STAFF REPORT: 09/22/2021 MEETING

APPLICATION NUMBER: 21-7477

ADDRESS: 2200 (2600) ATWATER

SCOPE: UPGRADE EIGHT (8) EXISTING LED SIGNAGE (CURRENTLY STATIC SURFACE), INSTALL TWO (2) NEW LED SIGNS; ALL SIGNS TO HAVE DIGITAL SURFACES

Existing Signs

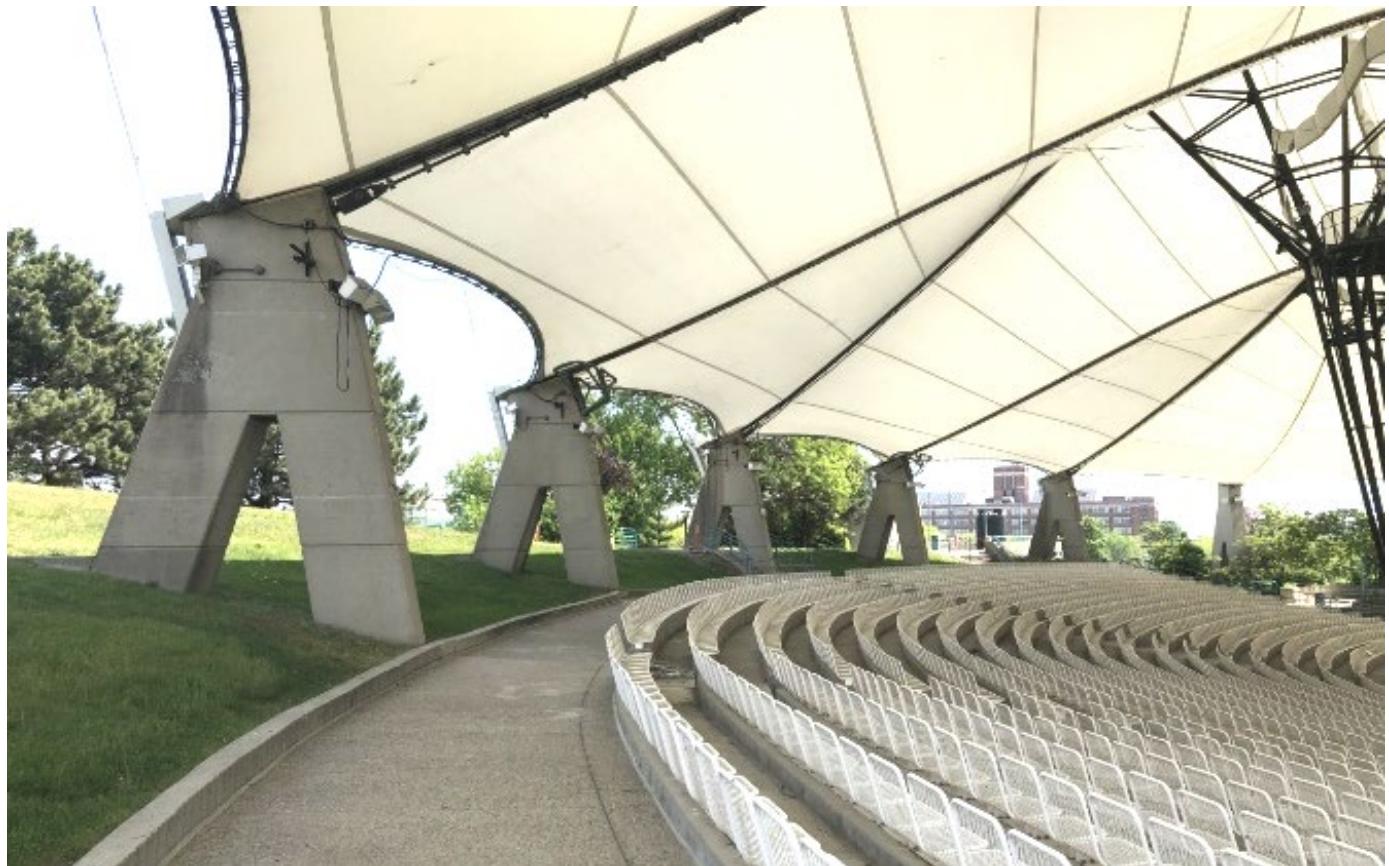
Existing signs located on the eastern side of the concrete inverted “V” membrane roof supports.

These are photos of north and south sides of one of the two “side” supports called out in the Final Report. The illuminated sign is on the northside, facing the amphitheater seats.

Looking southwest toward stage. Existing signs/ screens flank the stage.

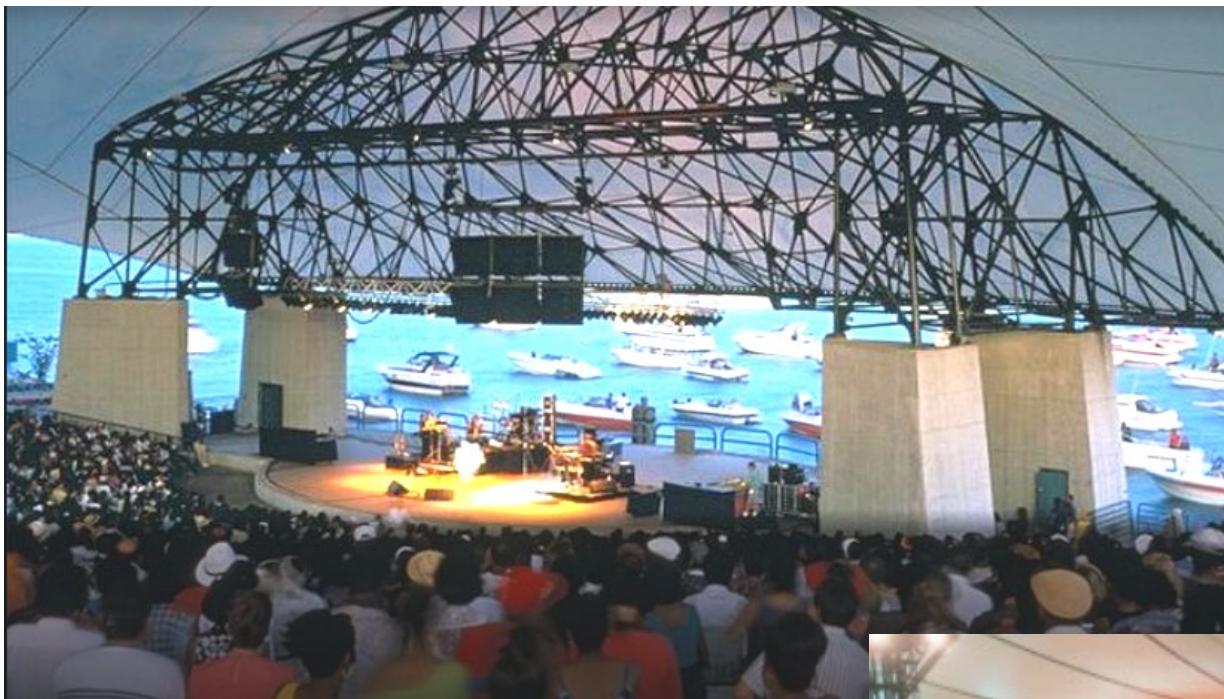
The seawall, designed by Shervish, Vogel and Merz, illustrates the intentional interrelationship of the amphitheater and nature and offers another example of why all views within, and toward, the district are character-defining features.

This undated photo, from tripadvisor.com, beautifully illustrates the dynamic contrast of the blank facades of the concrete supports against the river, as well as how they frame the performance.

Detroit Free Press photo, June 25, 2016 concert. The static signs shown in the above photo reduce the interdependent relationship of structure and site. Moving digital signs will further disrupt the district's environment.

Adhesive signs shown in a 2017 photo, cheneparkdetroit.com. The current application proposes moving graphic signs at these two river-facing locations.

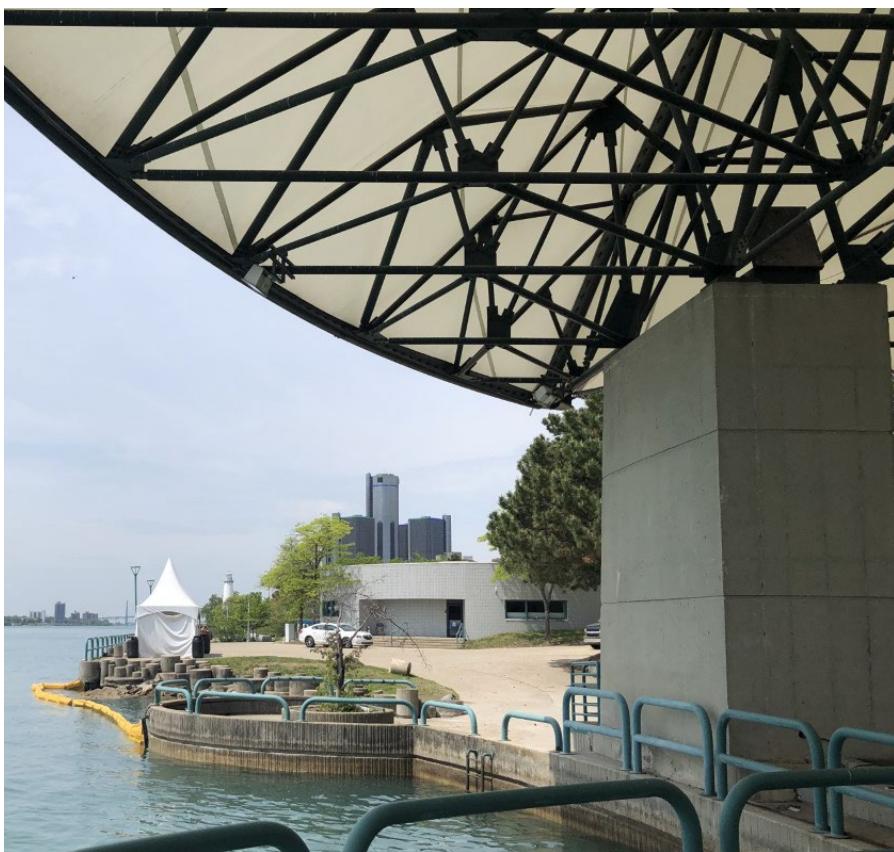
During HDC staff's May 2021 visit, the western roof support did not have a sign affixed to its river-facing elevation.

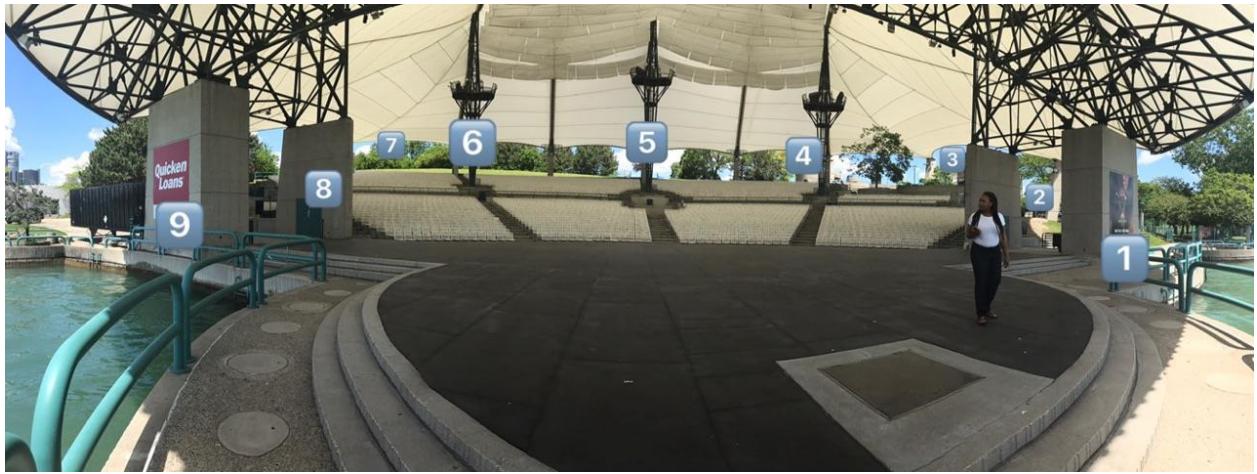
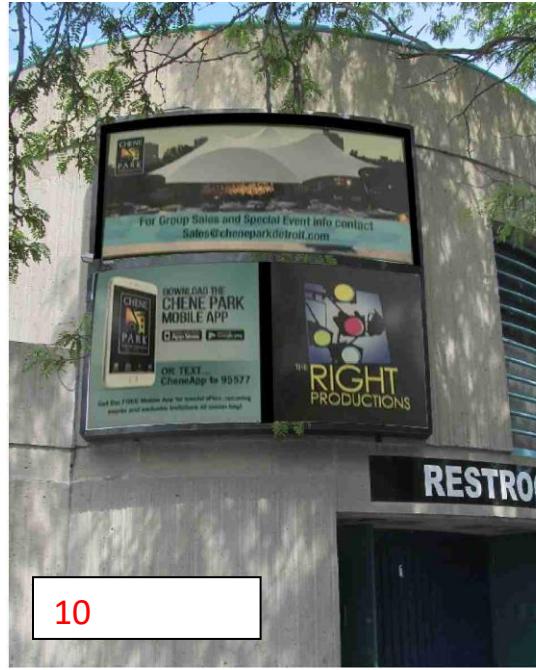
* The bottom 2 faces will have to be cut down to fit the bottom cabinet. Once they are cut they can't go back in the original cabinet.

* The red area is where we would need to add panels to fill in the space where the faces don't cover.
